PROCESS SYSTEMS INTERNATIONAL DOCUMENT APPROVAL CHECKLIST

PROJECT NAME: *Rev 1*
 PSI DOC. NO.: *049-8-298*

VENDOR NAME: *J. P.L. Consulting*
 REVISION NO.: *G*
 SUBMITTAL NO.: *55*
 STATUS: *Rev/app*

COMPRESSED AIR SKID
 KNWO COMPRESSOR
 DRYER, 200 GAL VERT TANK
 & FILTERS

DRAWING NUMBER
KAC-1841-G

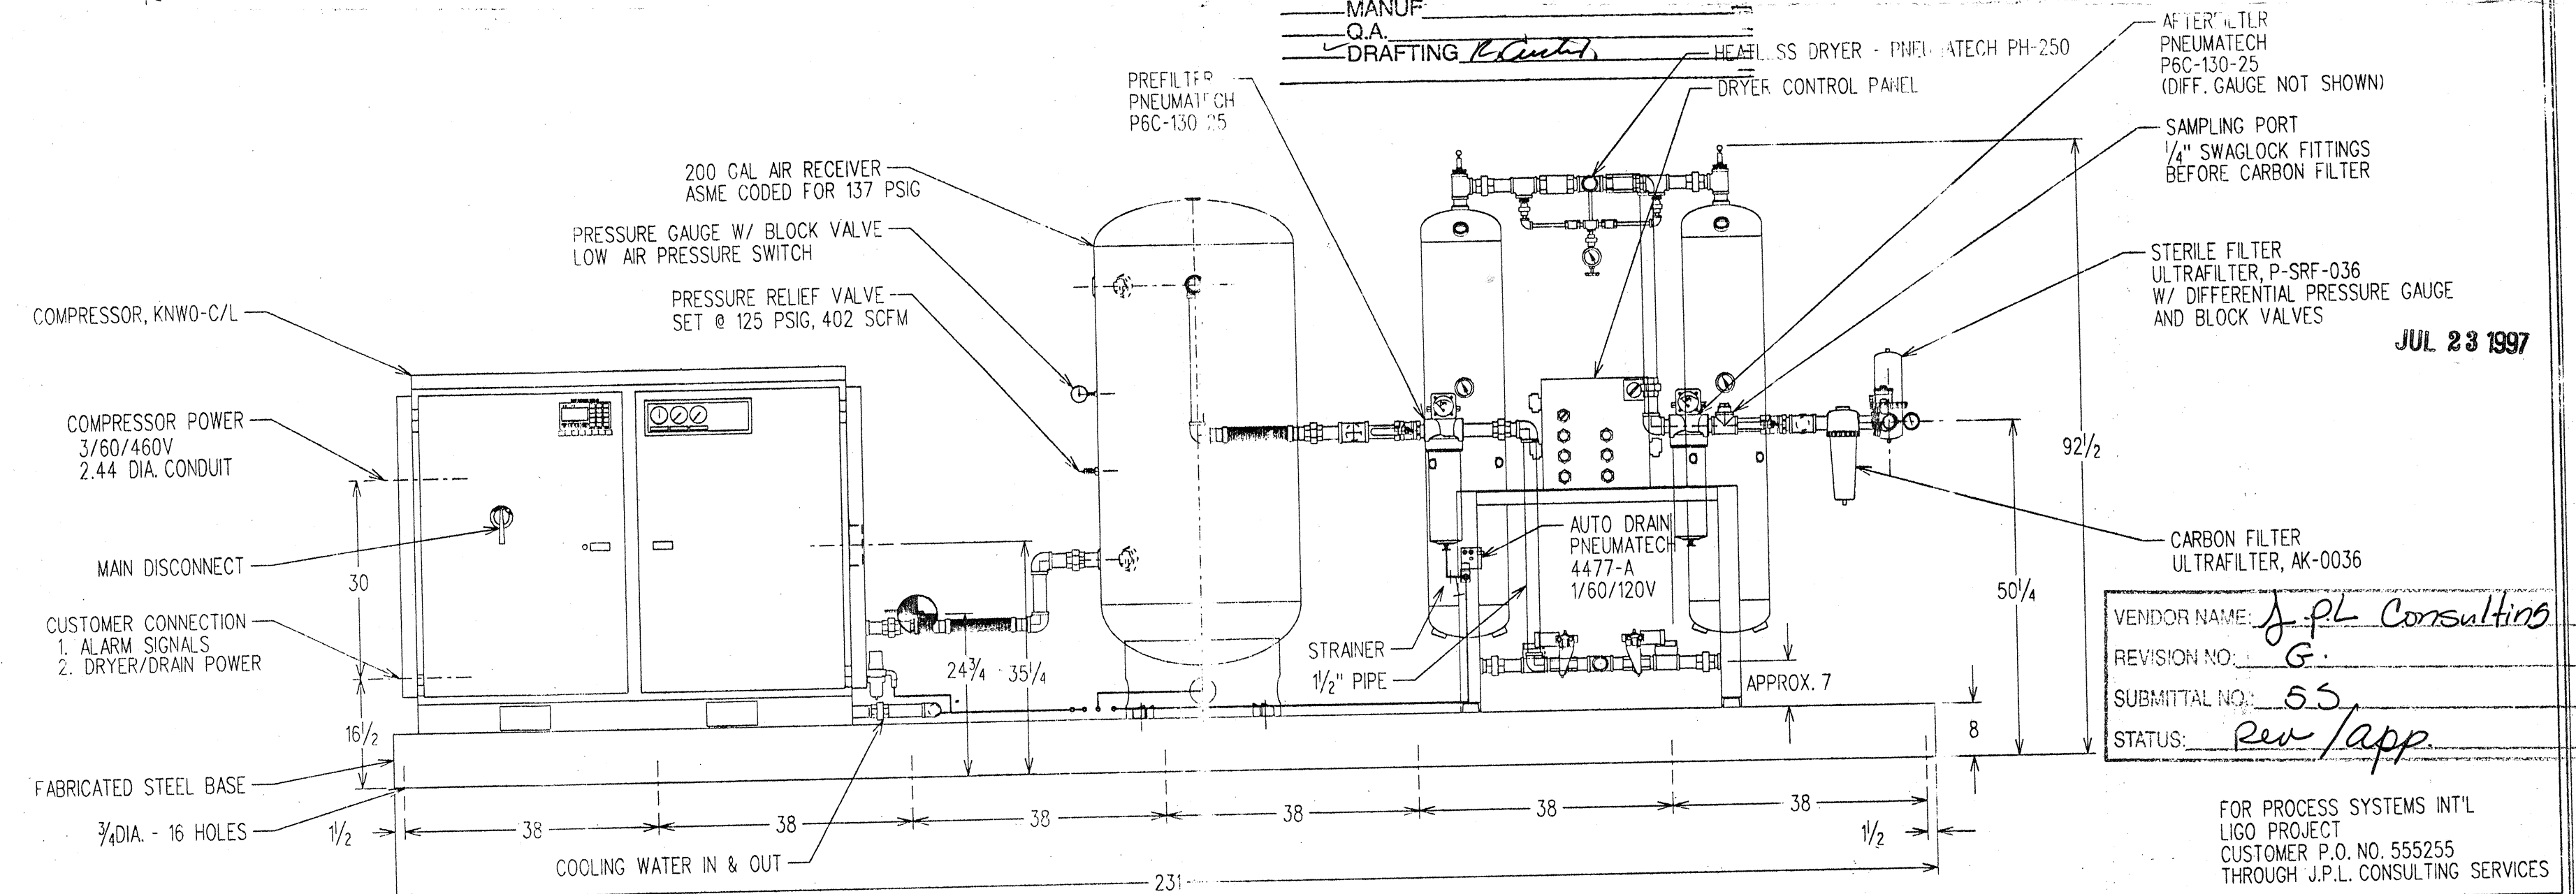
G	11 JUL 97	ETI	CORRECTED PER CUSTOMER COMMENTS	DRAWN	T. DUGAN	4/25/96
F	24 JUN 97	ETI	CORRECTED BYPASS AND FILTER LOCATION	CHECKED		
E	27 MAY 97	ETI	NOTE TO 2\" MUFFLER PER CUSTOMER COMMENTS	SHEET		SCALE NONE
LTR	DATE	BY	CHANGE	JOB NO.	96G0246, 96G0247
